From: Lowe, Claire (EGLE)
Sent: 2/24/2023 4:40:44 PM
To: "Shattuck, Terri (EGLE)" <ShattuckT@michigan.gov>
Subject: FW: Categorical determination - Cadillac casting - reply
Attachments: MX-5051_20230224_113352.pdf

Subject: Categorical determination - Cadillac casting

Cadillac Casting, Inc.

Dust Collection Scrubber Operations:

Mold making, Pouring, and Shakeout diagram
Including the North WWTP for wet scrubbers
2/23/2023

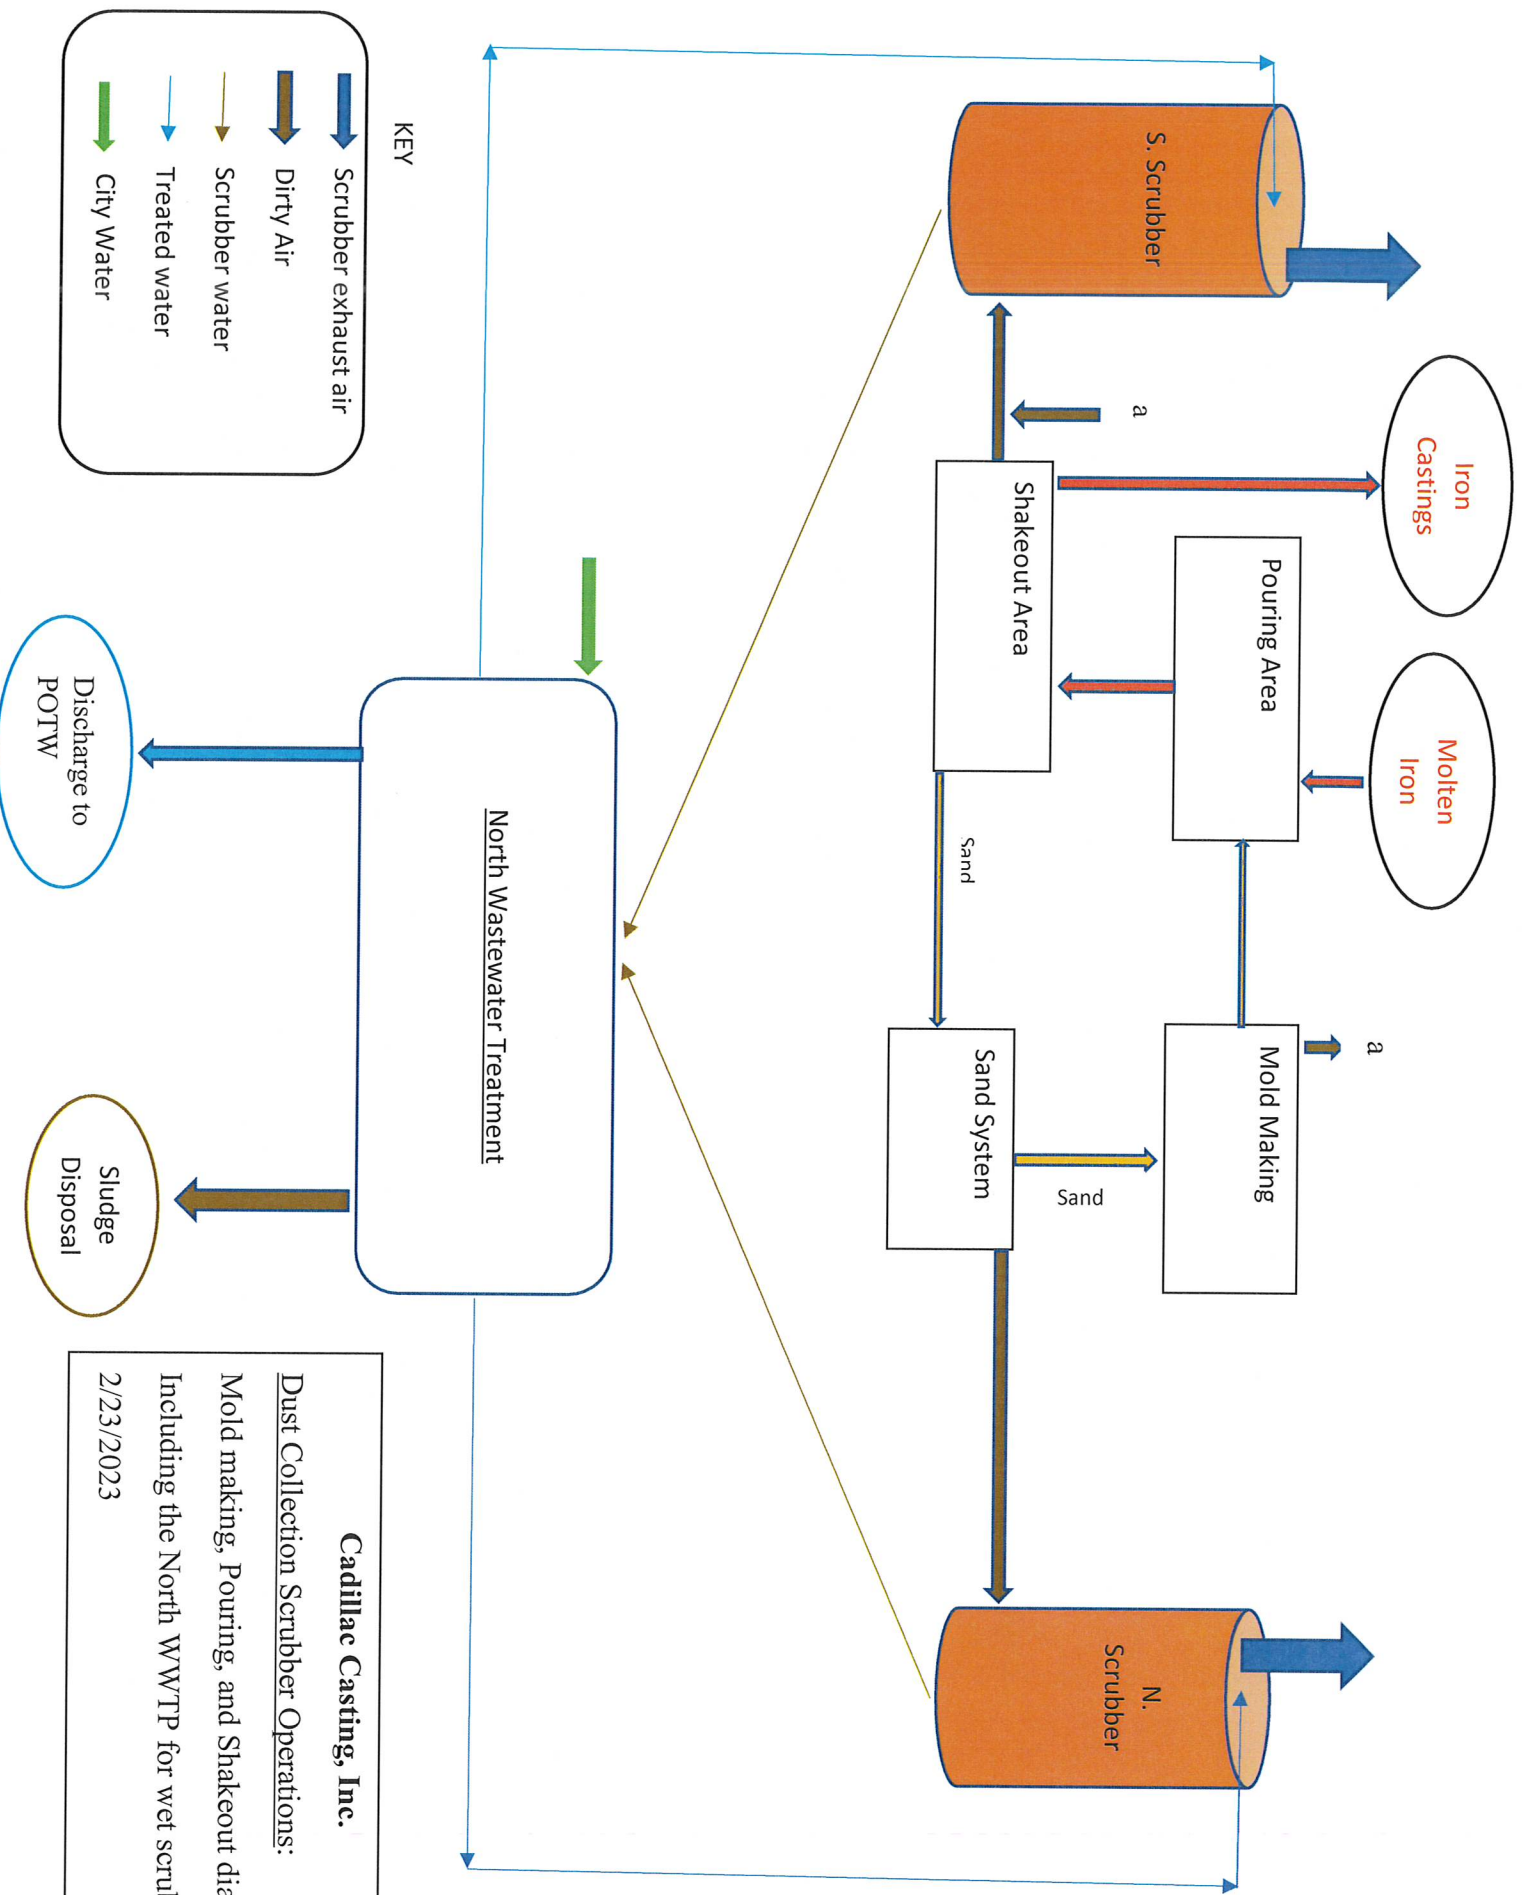
I finally got a process flow diagram from Cadillac Casting. I think that completes our requirements for the categorical determination. I don't see any additional processes in there that should be considered. Let me know if you want to discuss.

Here are my process flow diagrams for the Melt Furnace Scrubber Operations and for our Dust Collection Scrubber Operations.

My notes from previous discussions are that we fall under Part 464.36. These are the two operations we have that are listed.
